Asset Walk 6-9 weeks

Project: IBP 6100 Make Ready Suite 3600

**INTERNATIONAL BUSINESS
PARK
SPEC SUITE 3600**

DRAWING TITLE:
**LEVEL 03 MECHANICAL
PLAN**

1 LEVEL 03 MECHANICAL PLAN
SCALE: 1/8"=1'-0"

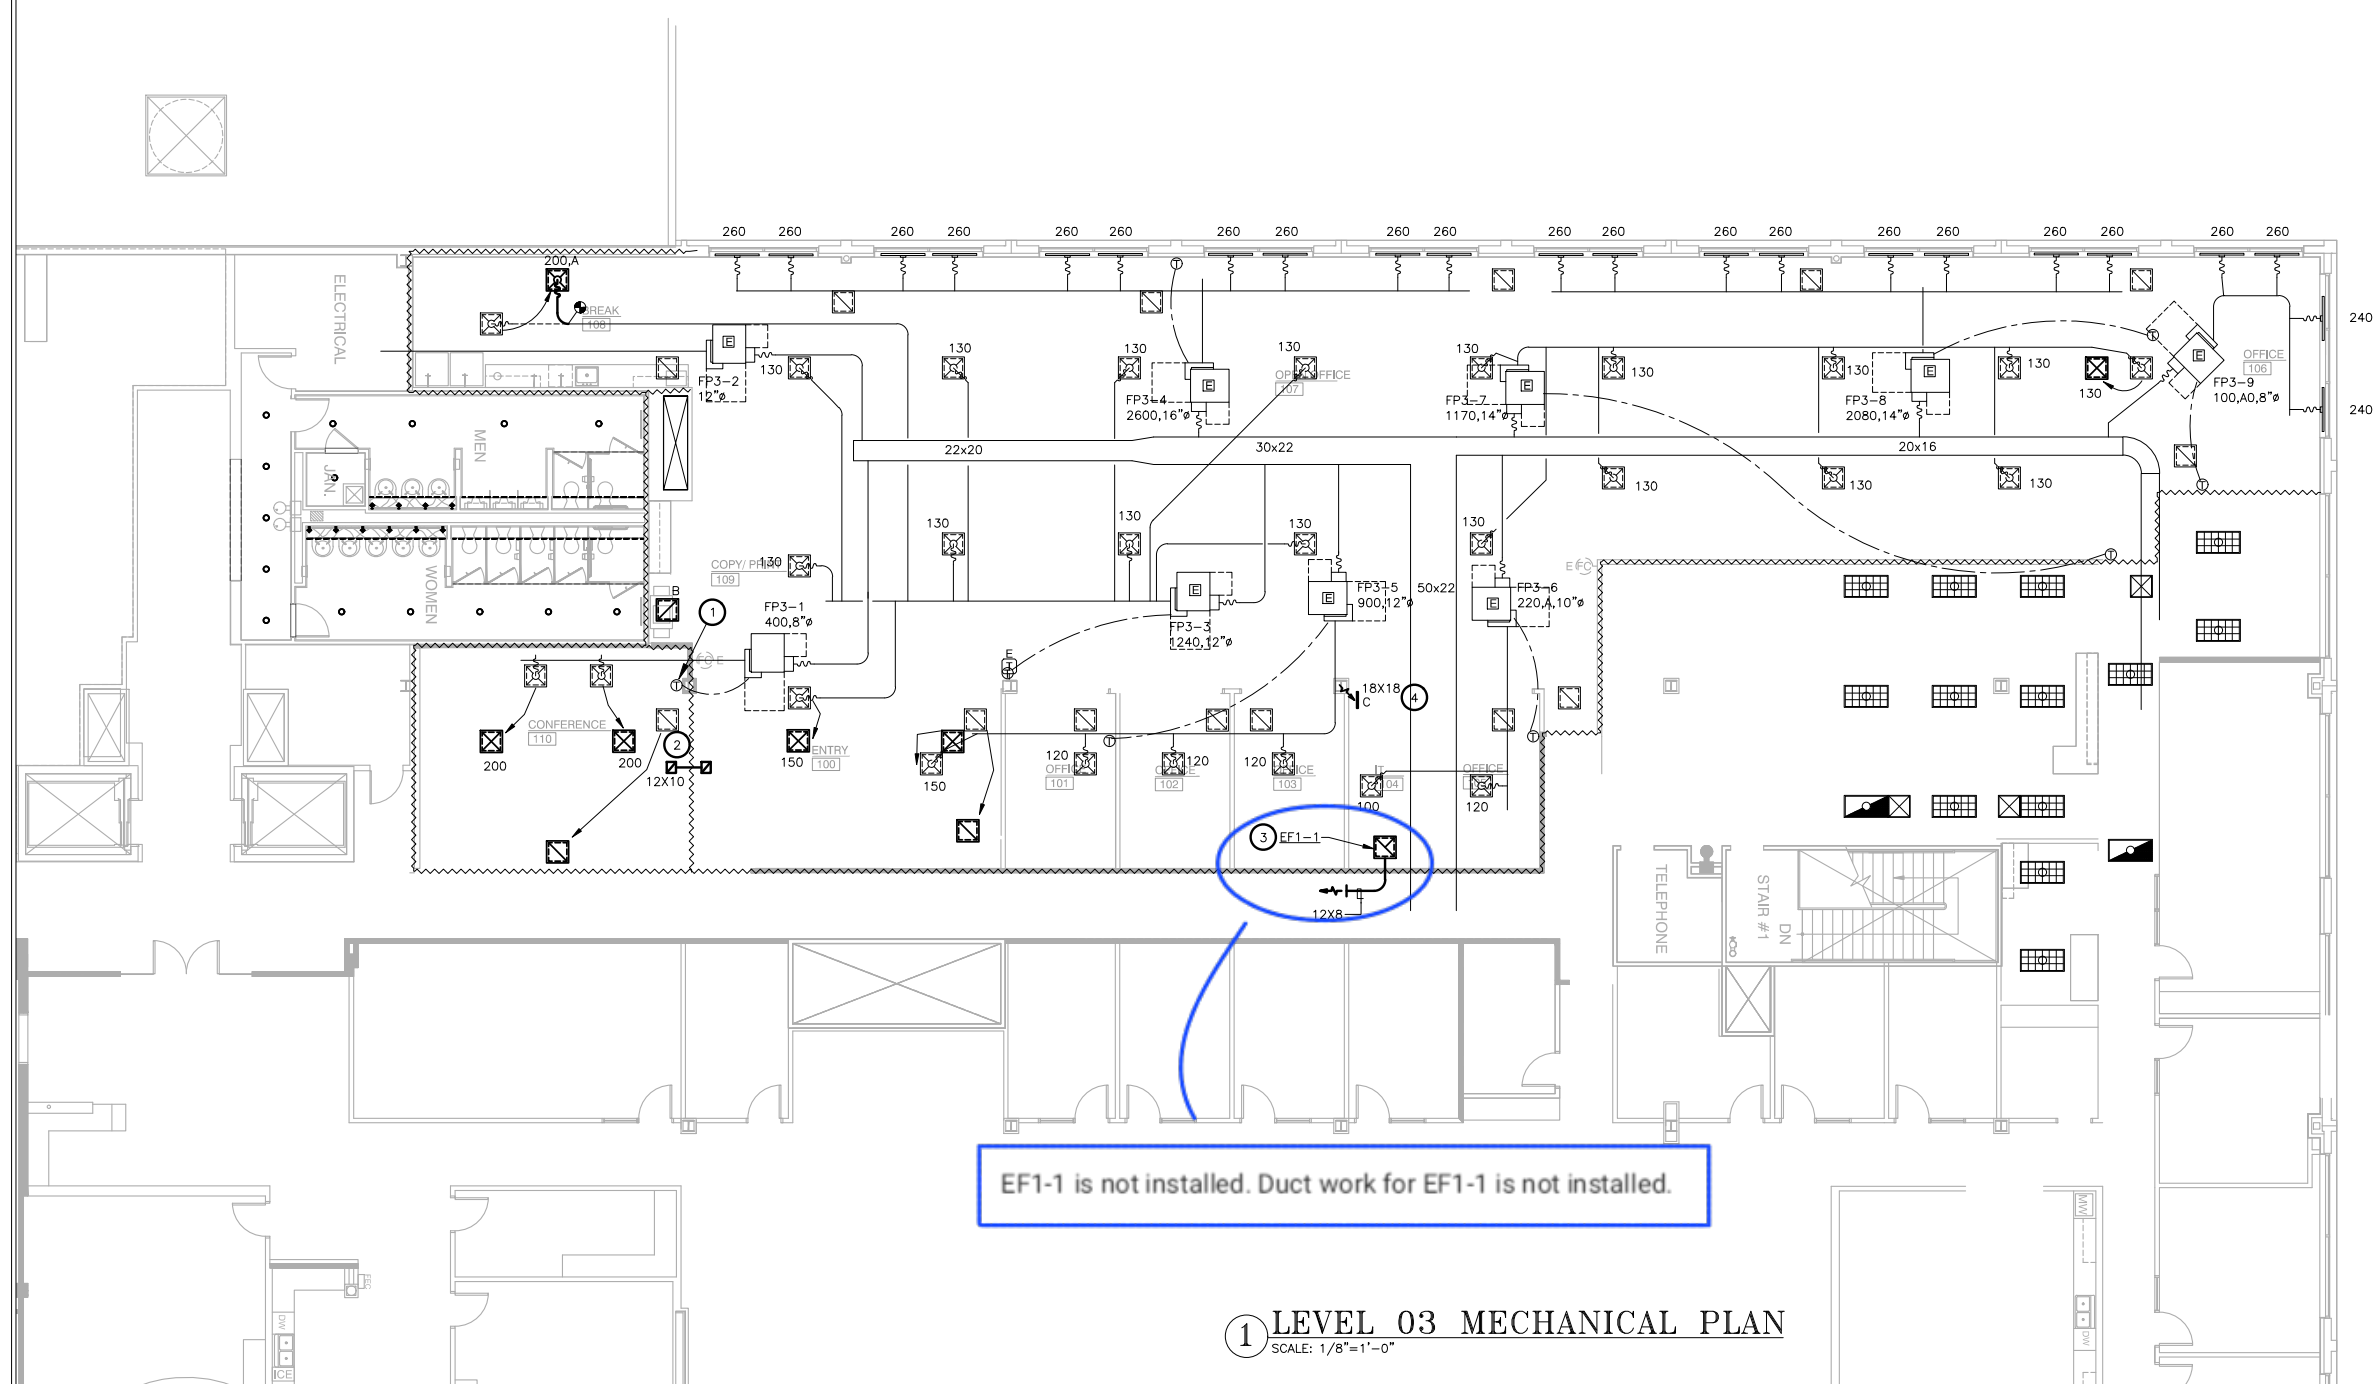
Date of Walk-Thru	7/31/2023
AHU/RTU	
RA & OA damper installed	Done in Shell.
Piping complete	Done in Shell.
Ductwork Connections Finalized and Sealed to Unit (OA, Return, Relief, Supply)	Done in Shell.
Power Landed to Unit/VFD	Done in Shell.
Comments	
Exhaust Fans	
Unit Mounted to Correct Curb/Location	No, see marked plans for details.
Disconnect Available	No.
Power to Fans/VFD	No.
Duct connected to fan/curb	No.
Motorized Dampers Installed	N/A
Comments	
Fan Coils/Small Inline AHU/HP/WSHP	
Unit Mounted in correct Location/Configuration	Done in Shell.
Power to Unit	Done in Shell.
Supply & Return Duct Installed	Done in Shell.
Outside air Duct Installed	Done in Shell.
Comments	
Return Air Path (marked up drawing attached)	
Are there enough transfer openings	Yes.
Are they sized correctly	Yes.
Are they in the correct location	Yes.
Comments	
VAVs	
VAV Hanging & Present	Yes.
Inlet Duct connected	Yes.
Discharge Duct connected	Yes.

EF1-1 is not installed. Duct work for EF1-1 is not installed.
